Access Compliance Report

Public Rights-of-Way

Intersection ID: 10029616	Main Street: KING_ARTHUR_DR	Cross Street: N/A	Location:	NE
ADA ID: 9530BDC0716A	Ramp Type: Perp	Initial Pass/Fail: Fail	Overall Compliance: No	Severity Score: 30
Codes/Mitigation Info/Possible Solution		Field Measurements/Component Compliance

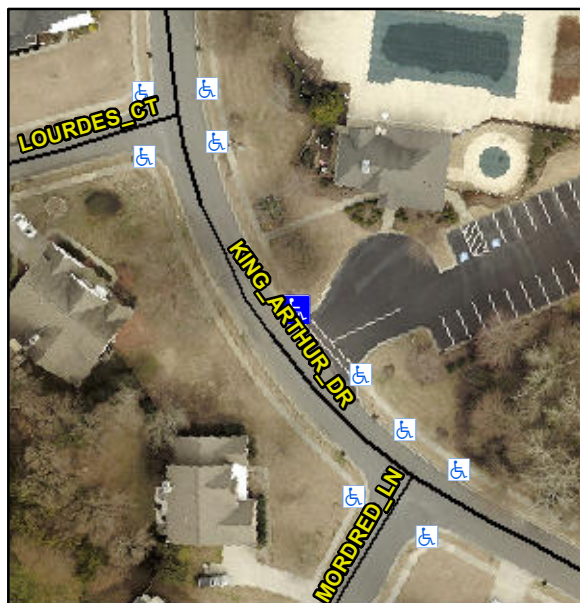
Not Found, R304.5.1, R304.2.2

Compliance	Description	Data	Compliance	Description	Data
N/A	Ramp Length (in)	103.0	No	Ramp Slope (%)	9.8
No	Ramp Width (in)	34.0	Yes	Ramp XSlope (%)	0.3
N/A	Flare Type LT	N/A	N/A	Flare Type RT	N/A
N/A	Flare Slope LT (%)	N/A	N/A	Flare Slope RT (%)	N/A
N/A	Flare Traversable LT?	N/A	N/A	Flare Traversable RT?	N/A
N/A	Landing Length (in)	N/A	N/A	DWS Provided?	N/A
N/A	Landing Width (in)	N/A	N/A	DWS Contrast?	N/A
N/A	Landing Slope (%)	N/A	N/A	DWS Length (in)	N/A
N/A	Landing X Slope (%)	N/A	N/A	DWS Full Width?	N/A
N/A	Landing Curb? (Y/N)	N/A	N/A	DWS Offset (in)	N/A
N/A	Shared Landing?	N/A			
N/A	Gutter Ponding?	N/A	N/A	Gutter Slope (%)	N/A
N/A	Gutter Lip Ht (in)	N/A	N/A	Gutter X Slope (%)	N/A
N/A	Painted X Walk1?	Yes	N/A	Painted X Walk2?	N/A
	X Walk 1 Direction	To SE		X Walk 2 Direction	N/A
N/A	X Walk 1 Width (in)	44.0	N/A	X Walk 2 Width (in)	N/A
	X Walk 1 Slope (%)	0.6		X Walk 2 Slope (%)	N/A
	X Walk 1 X Slope (%)	3.0		X Walk 2 X Slope (%)	N/A

Remove & Replace Entire Ramp.
